Sent: 13/11/2019 9:09:34 AM
Subject: 11 Moore Street, Clontarf - DA 2019/1149
Attachments: Letter Council 1.pdf;

Re: 11 Moore Street, Clontarf – DA 2019/1149

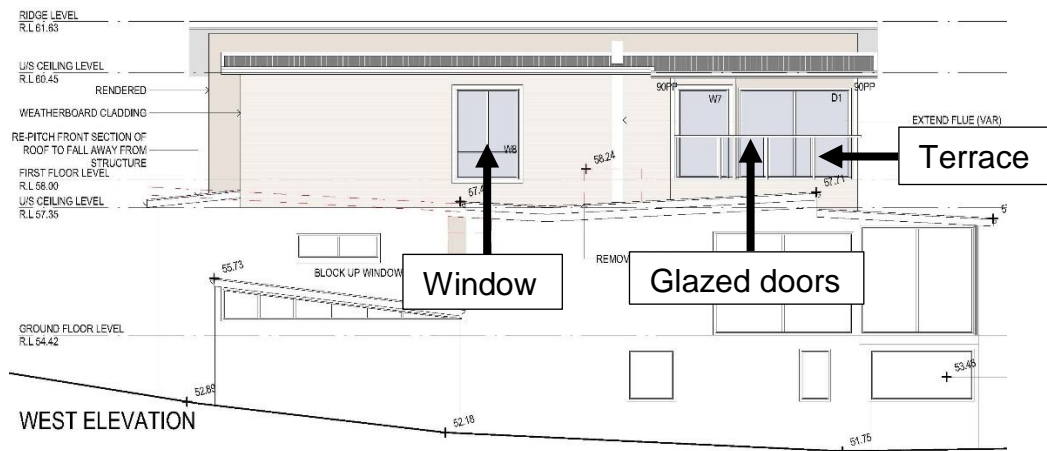
Comment: The building layout does not provide for privacy between the occupants of the neighbouring dwellings. The elements of the proposal that result in overlooking are the large areas of glazing on the western façade of the proposed upper level and the proposed upper terrace.

These elements are not designed to maximise privacy, but are designed to maximise views from the subject dwelling house. However, they provide direct views into the principal private open space and master bedroom of the neighbouring property owned by Mr Kremer.

The impact may be mitigated through the installation of a 1.6m high privacy screen along the entire western side of the proposed upper level terrace and obscure glazing to a height of 1.6m above floor level for the window that is proposed within the centre of the upper level western façade.
